TECHNICAL BULLETIN

MODEL/DERIVATIVE:
Discovery Series II

Bulletin N°: 0062
CDS. ref: L8620bu
Issue: 1
Date: 24.01.01

SCUFF MARKS ON OCCASIONAL REAR SEAT SQUAB (THIRD ROW)

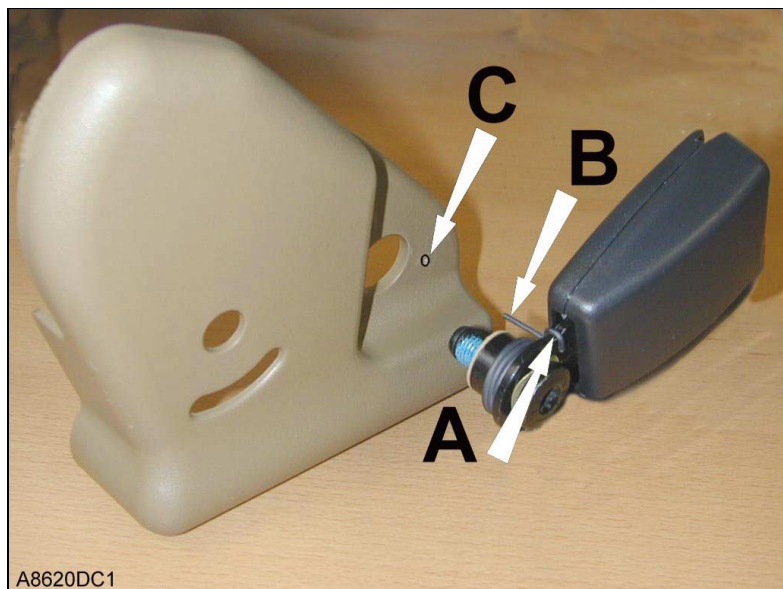
The customer complains of damage to the squab cover adjacent to the seat belt buckle.

Seat belt buckle remaining in raised position when seat is stowed.

Replace the inner squab hinge cover on both seats with modified covers incorporating a spring which automatically lowers the seat belt buckle. The new parts are now available in vehicle sets, refer to *PARTS INFORMATION*.

1. Pull off the squab release lever.
2. Remove the seat belt anchorage Torx bolt and remove buckle.
3. Remove the screw securing the hinge cover and remove cover.
4. Replace hinge cover with new cover from kit and secure with screw.
5. Obtain the appropriate return spring from the kit, (left hand illustrated) and engage with the seat belt buckle as shown at 'A'.

6. Refit seat belt buckle, locating the free end of the spring 'B', into hole 'C' in the hinge cover.
7. Apply lubricant such as STC4224 (Tefoil with PTFE spray) to the seat belt buckle pivot and anti-rattle washer.

8. Tighten the seat belt buckle Torx bolt to 32Nm.
 9. Confirm that the seat belt buckle returns freely to the lower position when released.
 10. Refit squab release lever.
 11. Repeat for other seat.
-
